SERVICE BULLETIN

No. 228

**CHRYSLER
CORPORATION****ATTENTION - SERVICE MANAGER**Date April 22, 1974

GROUP1
Cooling**SUBJECT**Cooling System
Change**MODEL AFFECTED**LM 318 Inboard
and V-Drive

RAW WATER COOLING SYSTEM

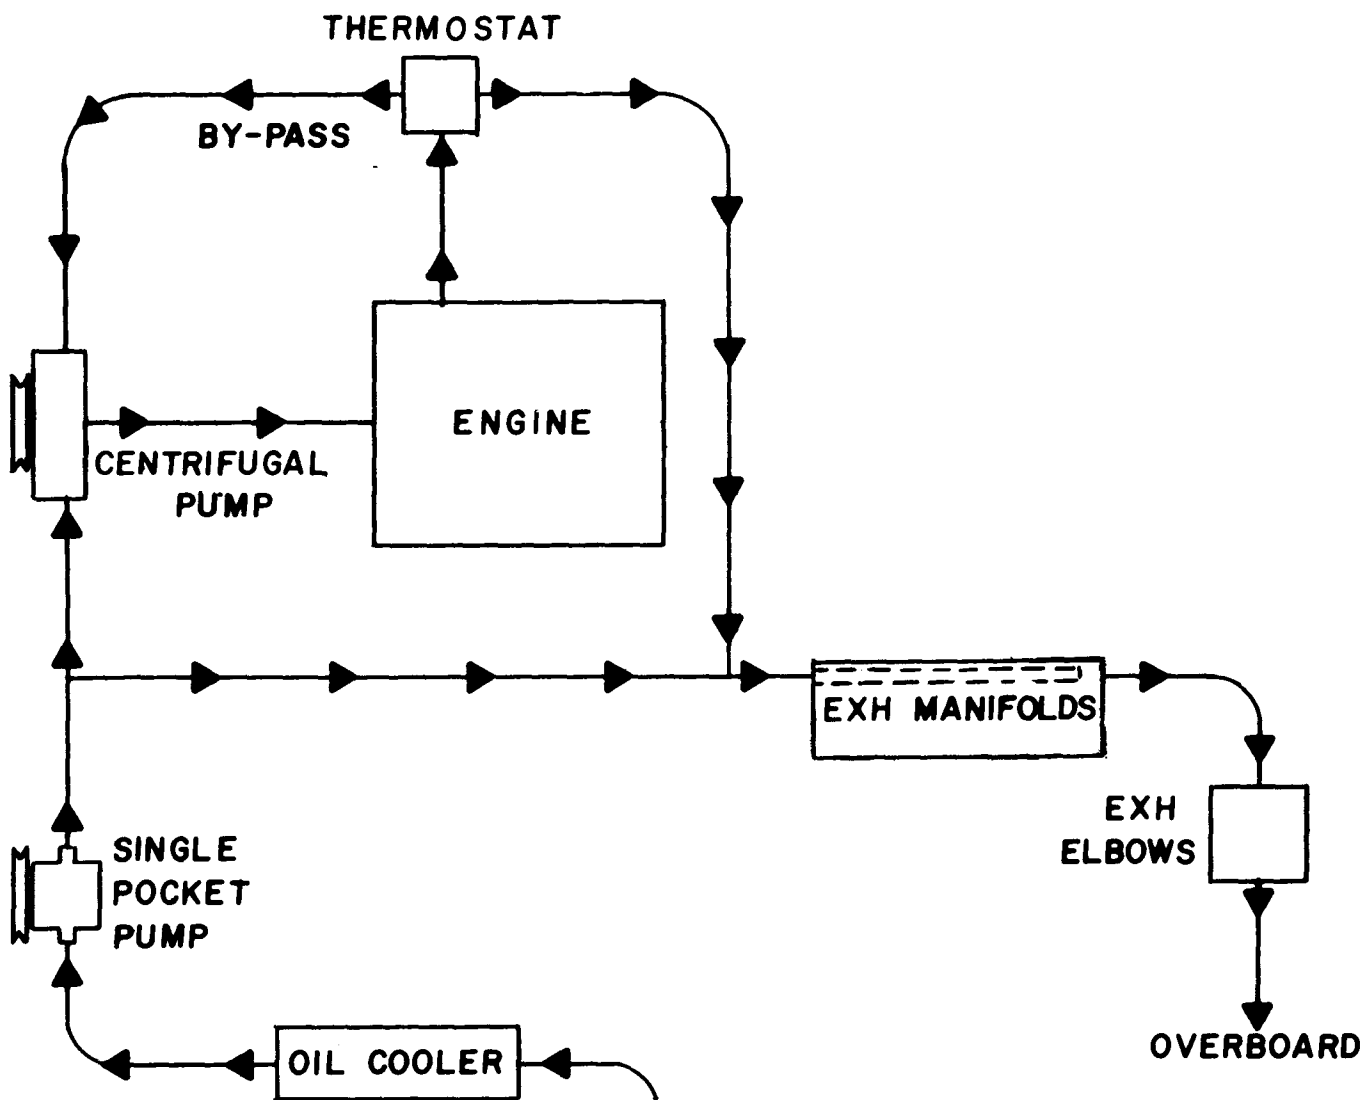
As shown in the water flow diagram on Page 3 the new cooling system uses a single pocket rubber impeller type pump to supply cooling water to a centrifugal type water pump which circulates the water through the engine and exhaust manifolds.

Major components affected by this change are the water pump chain case cover, thermostat and housing, intake manifold, exhaust manifold water outlet tubes, reverse gear oil cooler (from 1" water connection to 1-1/4") and the engine cooling system hoses.

The new cooling system requires a hull water inlet of minimum 1" I.D. and, as noted on the water circuit diagram, the use of an inlet strainer is recommended. Heavy duty non-collapsible type hose, or wire reinforced hose should be used for the water inlet system and all fittings and hoses of the inlet system should be equal to, or larger than the water pump inlet.

INLET 1.25 O.D. - NO WATER BY-PASS
TEE REQUIRED
INLET STRAINER RECOMMENDED
